Re: JOML B remodeling
First notice of damage
Room 301 and 302, Owre Hall

TO: Mr. Gordon Dahlen, Construction Superintendent, U of M
FROM: Gerald T. Bratt, Dept. of Biochemistry *GTB*
SUBJECT: JOML-13 Construction Project-
Water Damage - Deionized Water Line Breakage 2/25/79

TO: Clinton Hewitt
FROM: Paul J. Maupin *Paul*
SUBJECT: JOML-Remodeling Project
Response to Departmental Comments

MECHANICAL SKETCH #2

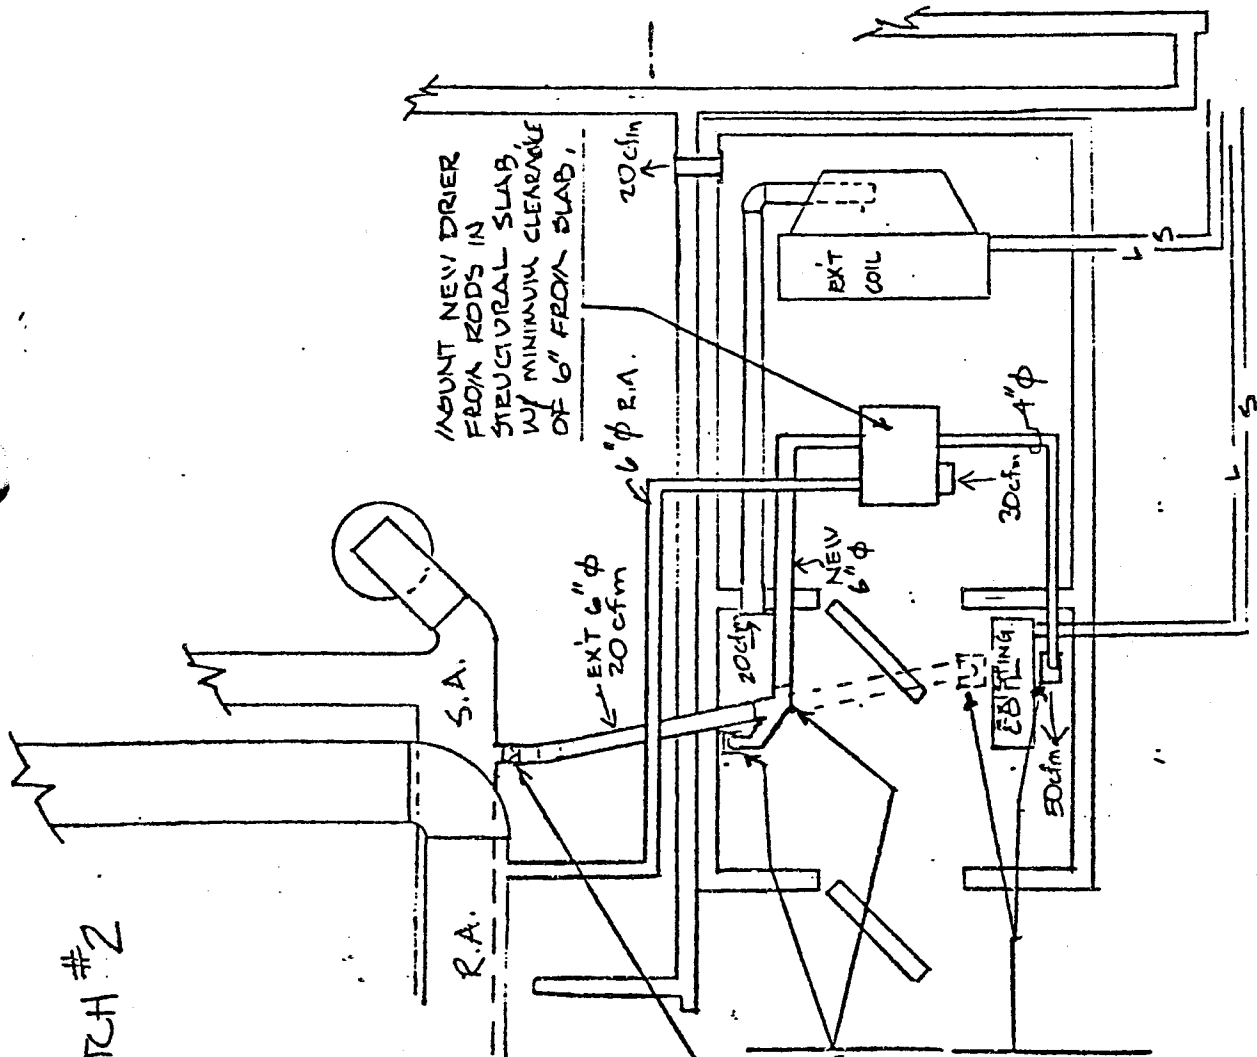
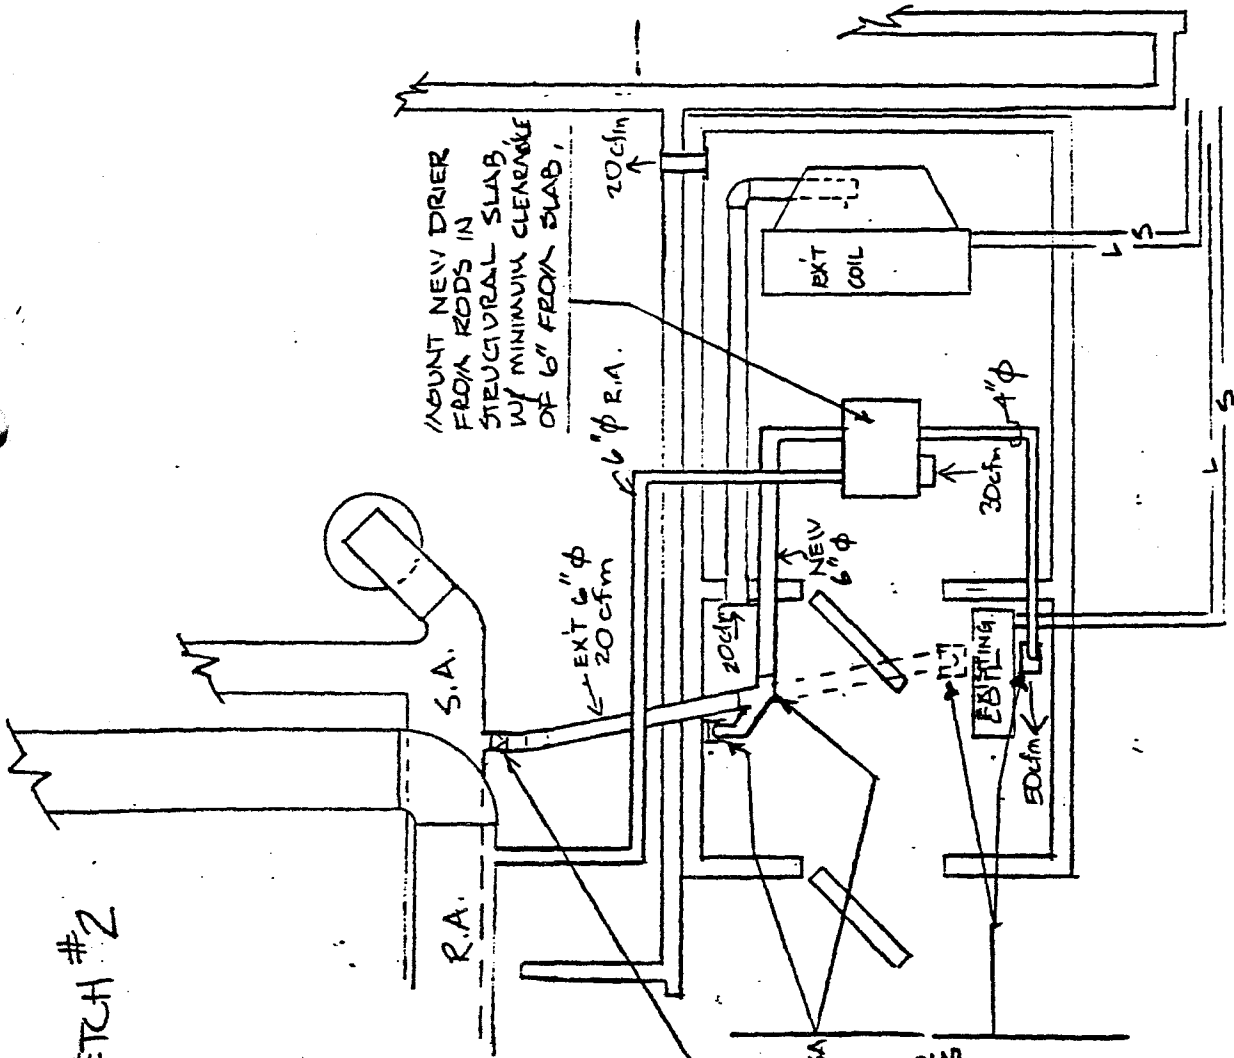
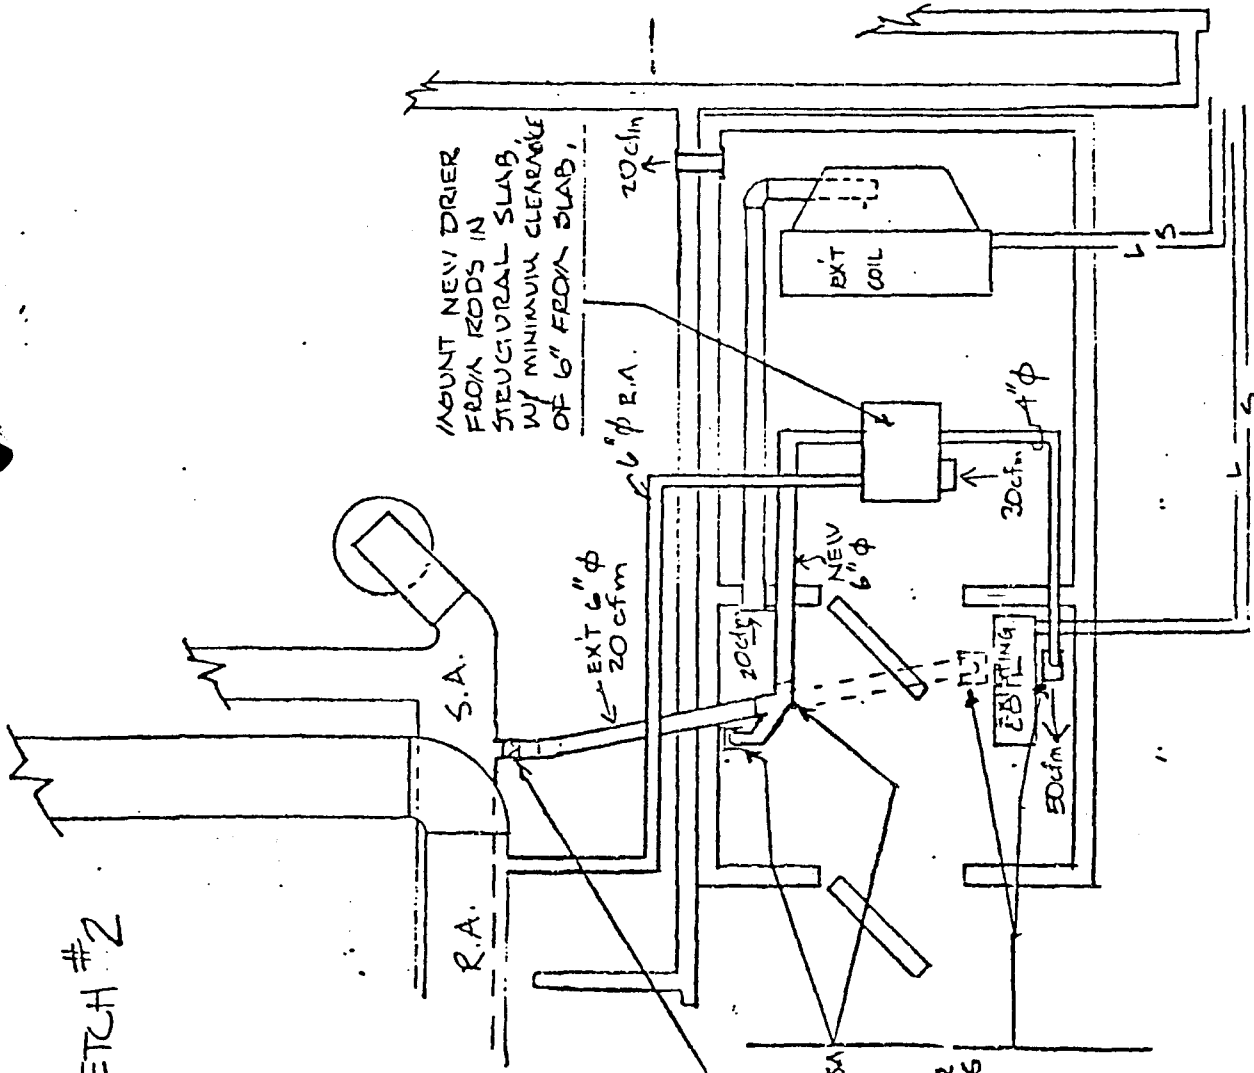
INSTALL NEW DRIER FROM REBARS IN STRUCTURAL SLAB W/ MINIMUM CLEARANCE OF 6" FROM SLAB.
